Interactive comment on “Water resources in the Badain Jaran Desert, China: New insight from isotopes” by Xiujie Wu et al.

Reviewer 2ijjZ General opinion This manuscript (hess-2016-692; Water resources in the Badain Jaran Desert, China: New insight from isotopes Xiujie Wu, Xu-Sheng Wang, Yang Wang, and Bill X. Hu) is a concise presentation of the application of well-established isotope techniques in identification of groundwater sources for a group of desert lakes in China. A relatively small amount of isotopic data points to recent precipitation being the sole source of water in the coupled groundwater-surface water system. The isotopic evidence for that seems to be unequivocal, however, some questions (see specific comments) should be addressed in order to strengthen the line of reasoning. On the other hand, data on stable isotopic composition of DIC are not used at all and the part explaining ^{14}C patterns requires some elaboration. Interpretation of presented data could be supported with a more detailed description of the hydrological

Fig. 1. Figure 1: Maps showing location of the Badain Jaran Desert (A), the Badain lake sampling area (B) and the Sumu Jaran lake sampling area (C). W34 in (A) is sampling site of Gates et al. (2008a).

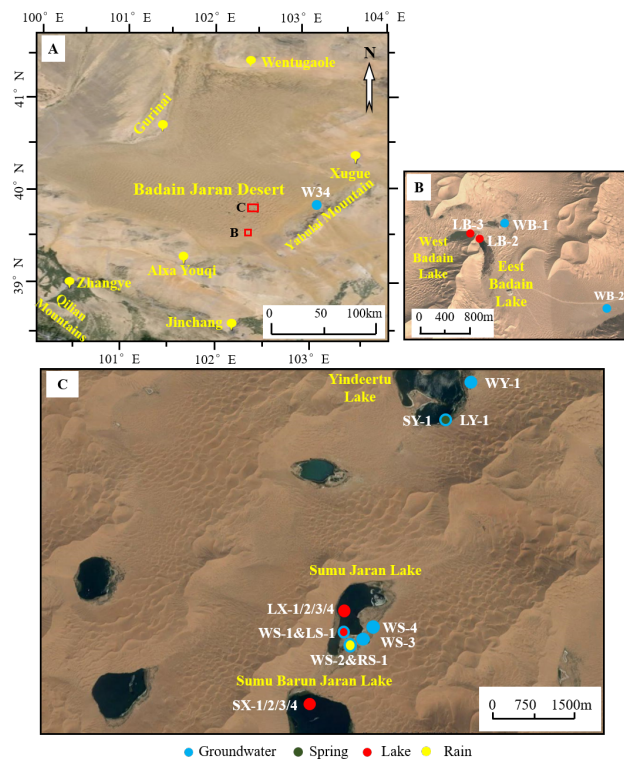
Specific comments 1. Given that only few lakes were sampled a question arises, not addressed in the manuscript, if results of this study apply to all lakes of the Badain Jaran Desert. How big is the part of the desert where the lakes occur? It is not delineated on Fig. 1. Is the hydrogeological setting uniform throughout that part of the desert, so that the recharge – discharge pattern proposed in the manuscript might apply for the whole area? Reply: This is a constructive comment. Accordingly, in the revised manuscript, additional information and discussions are presented to address the question: (1) Section 2 has been significantly revised to show how the lakes are limited in the southeastern part of the desert and concentrated in a relatively small area (a 50-km-width rectangular zone around site-C in Fig. 1A) as well as how the aquifer system of sediments is relatively uniform in horizontal in the desert. At the regional scale, the Quaternary sediments are relatively uniform as fine sands and role as a continuous unconfined aquifer. The thickness of this aquifer is generally 100-300 m. (see Page 3, Line 7-9)

been also confirmed from the measurements of temperature and electric conductivity profiles in the summer (Chen et al., 2015). (see Page 7, Line 8-10) 7. (p. 9, lines 13-14) Are there any data on groundwater flow directions/hydraulic heads in the lake area to support this notion? Generally, the hydrogeological conditions are poorly explained in the manuscript. Reply: These sentences are misleading. They are deleted in the revised version. Section 2 has been significantly revised to express the hydrogeological conditions in the BJD. (see Page 3, Line 7-8, 16-23) 8. (p.10, lines 5-14) The bicarbonate and ^{13}C DIC data do not support the gradual dilution of ^{14}C with the old inorganic carbon derived from carbonate dissolution along the entire groundwater pathway. Both parameters change significantly only between points WS2 to WS1 pointing to isotopic exchange as a cause of the apparent increase of radiocarbon ages between WS4 to WS2. This discussion would benefit from any quantitative considerations on the isotopic evolution of DIC along the transect. However, the conditions of carbonate dissolution and isotopic exchange are controlled by aquifer properties which are not described in the manuscript. Reply: We agree that the varying ^{14}C and ^{13}C are not fully caused by the gradual dilution. In the revised manuscript, additional information about the aquifer properties are presented in Section 2 and Section 5.3. A quantitative analysis of the possible radiocarbon dilution factor is added and discussed in Section 5.3. The corrected ^{14}C dating results are shown in Table 3. (see Page 3, Line 7-8, 16-23; see Page 11, Line 26-33; Page 12, Line 1-14) 9. (p.10, lines 27-29) The vertical homogeneity of lake water implies only good vertical mixing. The (isotopic?) steady state is a separate issue and can be assessed only from the temporal patterns. Is there any evidence for lake waters being in the steady state? By the way, what causes vertical mixing of the lakes? Wind or diurnal water temperature fluctuations? Reply: Accept! "Steady state" is not confirmed. In my opinion, the discharge of groundwater to the lakes is the most possible reason that courses vertical mixing. (see Page 12, Line 33) 10. Figs. 1B and 8 are not consistent with respect to the relative positions of wells and the Sumu Jaran Lake. The lake is located between W3 and W2 in Fig. 1B and to the west of W1 in Fig.8. Reply: The Fig 1B in last version is enlarged and changed to

Fig 1C and the exhibiting size of it is revised to clearly show the position of wells. (see Page 18) Technical comments 11. (p. 1, line 26) please remove “arid regions” Reply: It is revised in the manuscript. 12. (p. 7, line 22) “and ARE strongly” Reply: It is revised in the manuscript. 13. Fig. 7. Should be “brackish” not “blackish” Reply: It is revised in the manuscript.
